**SANITARY
EFFLUENT**

RE: RESPONSE TO DISAPPROVAL
INVESTIGATION WORK PLAN
SANITARY LAGOON
WESTERN REFINING SOUTHWEST INC., GALLUP REFINERY
EPA ID # NMD000333211
HWB-WRG-18-004

INVESTIGATION WORK PLAN

**INVESTIGATION WORK PLAN
Sanitary Lagoon**

Figure 5 Sanitary Lagoon Proposed Soil Boring Locations Adjacent to Pipeline

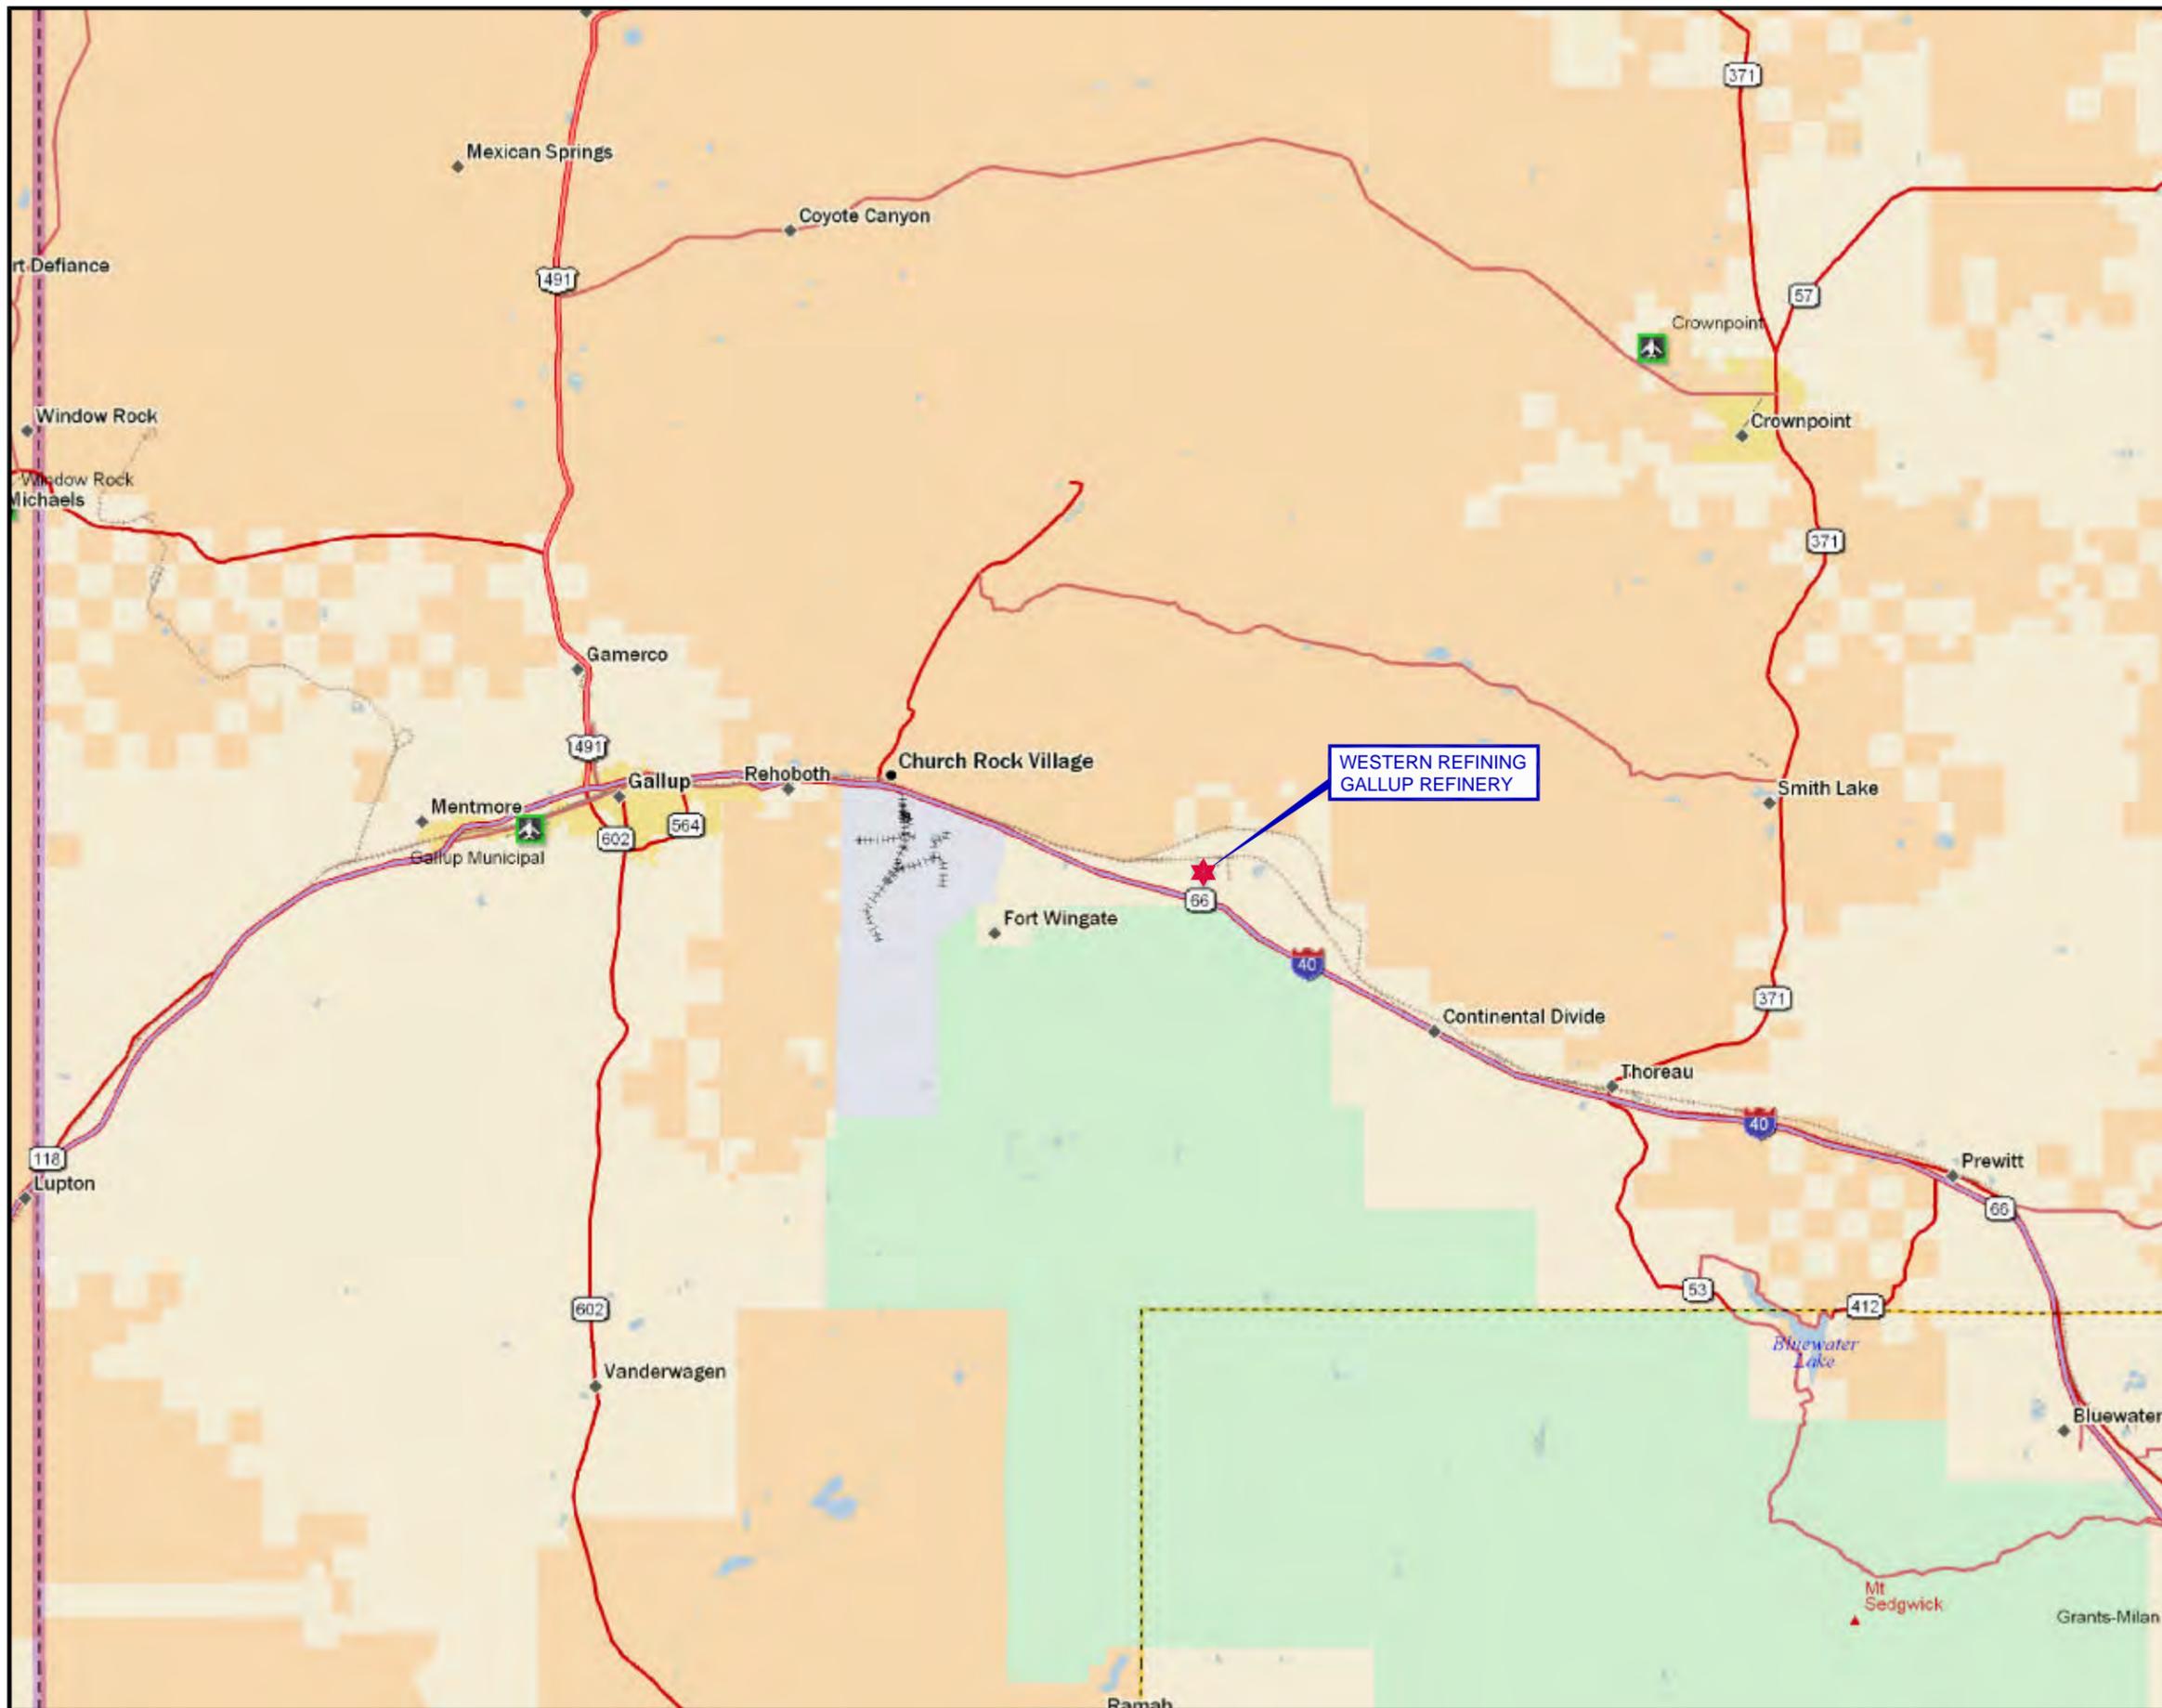
Comment 10 in NMED's March 15, 2018 *Disapproval* states, "[t]he Permittee must propose to collect soil samples from within the sanitary lagoon and along the pipe where the holes were discovered." The proposed locations of soil boring are all depicted within the boundary of the Sanitary Lagoon in Figure 3, *Sanitary Lagoon Proposed Soil Sample Locations*. As stated in the comment, the Permittee must also propose to collect multiple soil samples along the pipeline from depths directly below the depth of the pipe from the Sanitary Lagoon back to the potential source area identified as Area A in the *Response to NMED Disapproval Sanitary Lagoon Investigation*, dated May 31, 2018. Provide a figure showing the proposed sampling locations along the pipeline.

Gallup Refinery Response: Much of the pipeline immediately south of the lagoon has been excavated with the trench partially collapsed. The trench is deep, with depths possibly as great as 15 feet, thus it is a health and safety concern to collect samples from within this unshored excavation. In our recent meeting (September 19, 2018), we discussed this concern and a suggestion was made to attempt angled borings. The Work Plan has been revised to include additional locations along the pipeline south of the lagoon. We will attempt angled borings, but the rig will need to be placed a safe distance from the excavation and it likely will not be possible to actually collect soil samples from "directly below the depth of the pipe from the Sanitary Lagoon". The latest comment refers to collecting samples all the way back to "Area A." We recently submitted an Investigation Work Plan for Area of Concern (AOC) 35, which includes borings along

the sanitary piping through the northern portion of the truck loading rack, back towards the area previously identified as "Area A." Therefore, this Investigation Work Plan is focused on the length of pipeline extending south from the lagoon to the northwestern portion of AOC 35 (i.e., the area northwest of the additive tanks).

Section 4.1 is revised to add six additional soil borings along the pipeline and Section 4.1.3 is revised to explain the process that will be used to locate the pipeline prior to installing borings in areas where the exact location and depth is unknown.
